**1 Roof Plan**  
As Proposed

drawing status	PLANNING SUBMISSION
job title	FALKLAND ROAD
drawing title	SECTION 73 DRAWINGS ROOF PLAN
ISO 9001:2015 Quality Management BS EN 19650:2018 Information Management	ISO 14001:2015 Environmental Management

drawn by	MP	date	28.02.22	checked by	GP	scale	1:100
job no.	9013	drawing no.	CPM-01-R1-DR-A-7006	revision	P04	media	A3

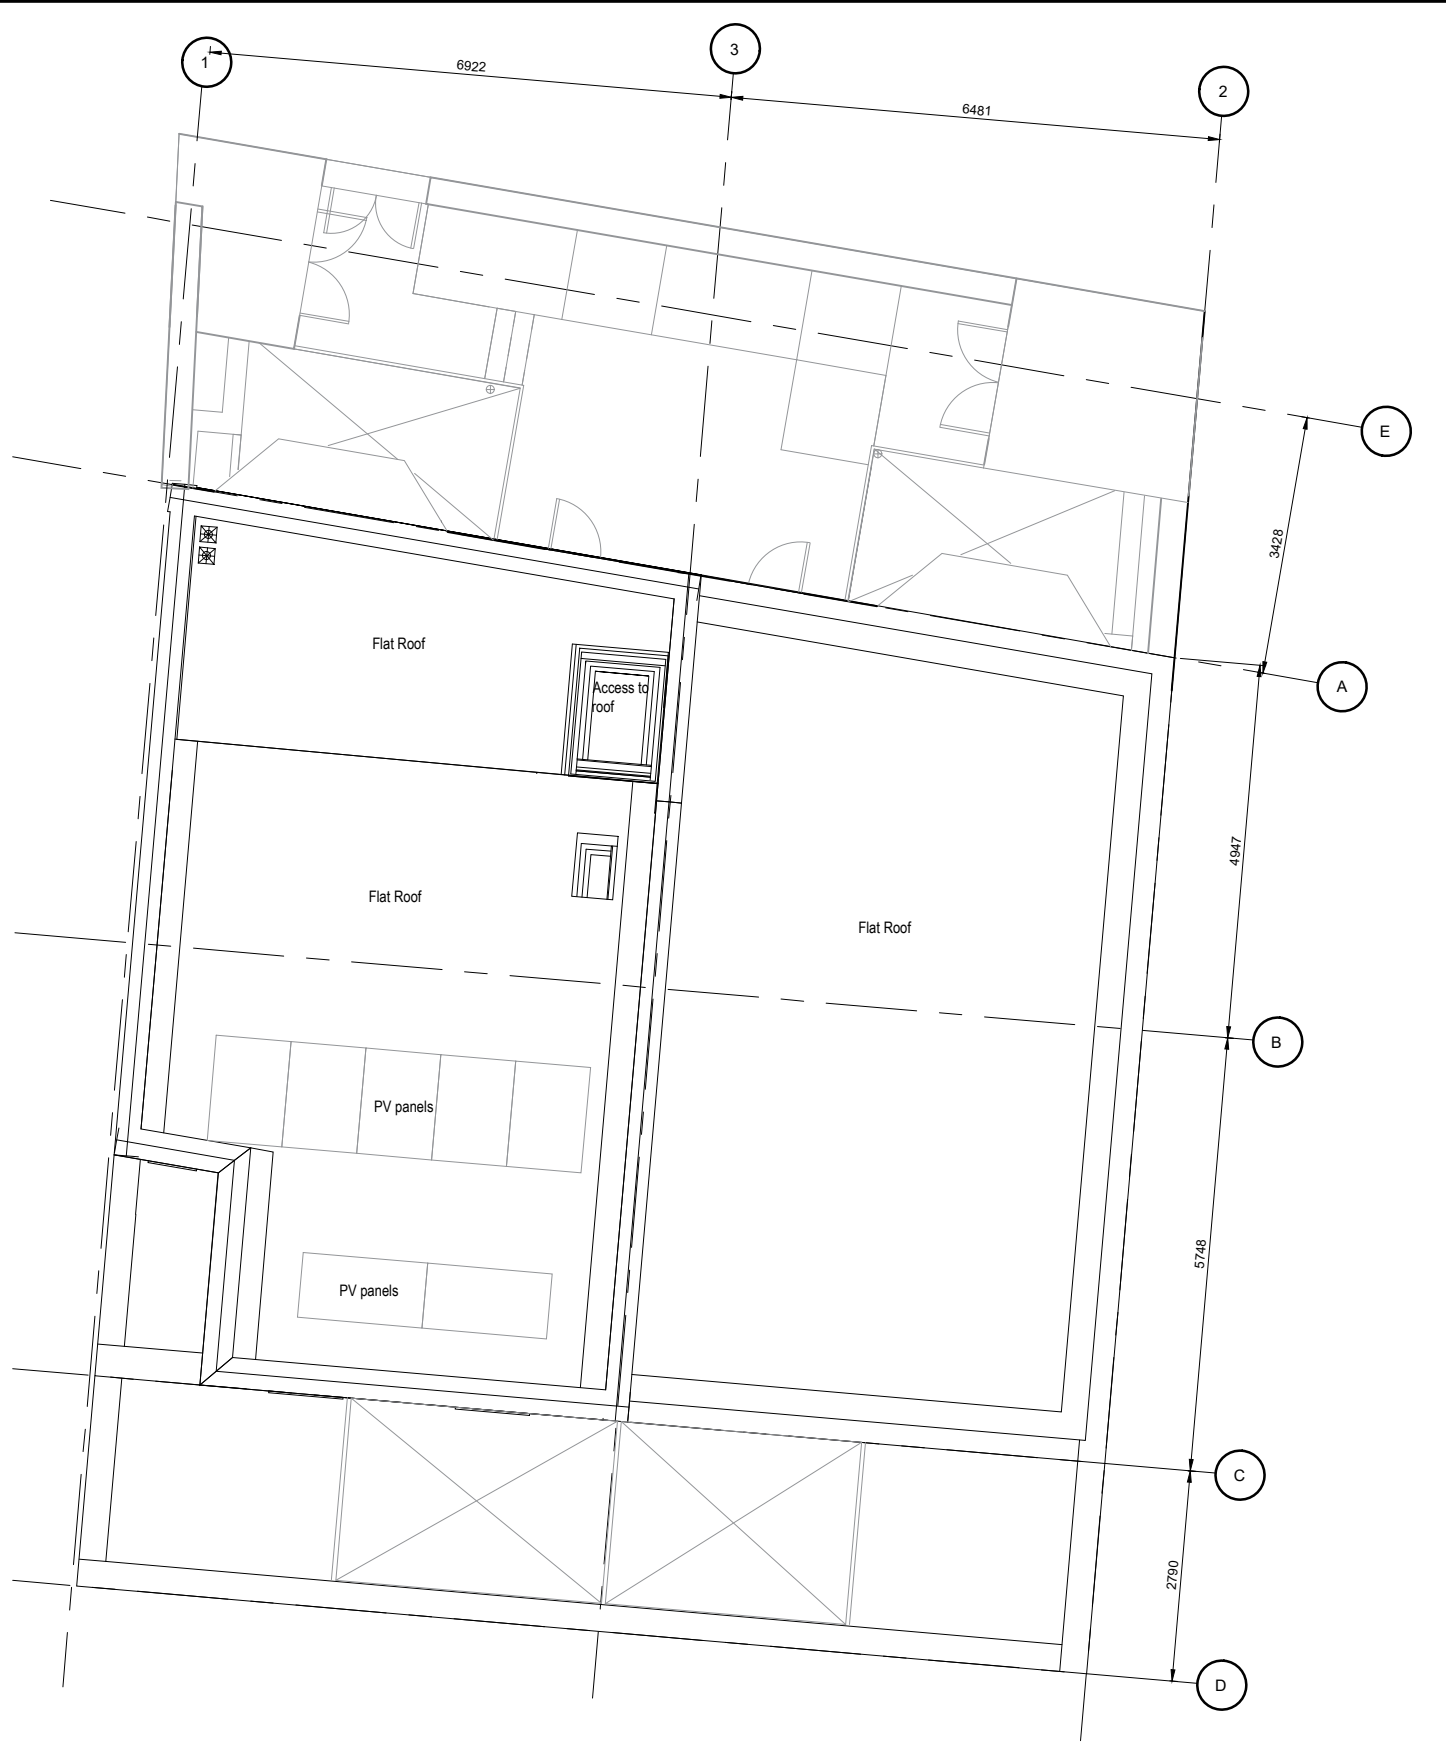
**Comments:**  
 1. Rooflight dimensions changed to reflect changes in stair width  
 2. Rooflight removed
